DATE: December 12, 2019

RE: #Case PL2019-220 – Creekview Office Parking Lot – 7109 West 78th Street

Figure 1 – Parking Area Encroachment into Shore Area

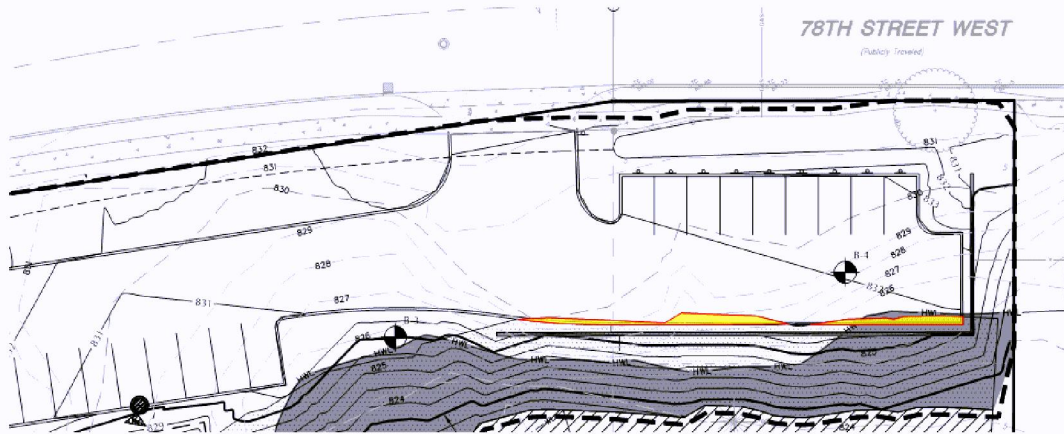
In evaluating the applicant's plans to construct a surface parking lot to serve the existing office building, staff has concluded that no reasonable alternative that does not impact the shore area exists for the location of the surface improvement. The encroachment of the surface parking area into the shore area is minimized, limited to approximately 190 square feet in the southeast corner of the parking area – see highlighted area in Figure 1. The proposed location for the parking area is the only location on site that additional parking areas can be constructed. The existing parking lot to the south and west of the office building is fully-utilized from a parking quantity standpoint. Additional parking stalls cannot be installed in a quantity that is equivalent or

approximate to the proposed parking area east of the building. As a result, the area east of the existing office building is the logical and reasonable location to site additional surface parking.
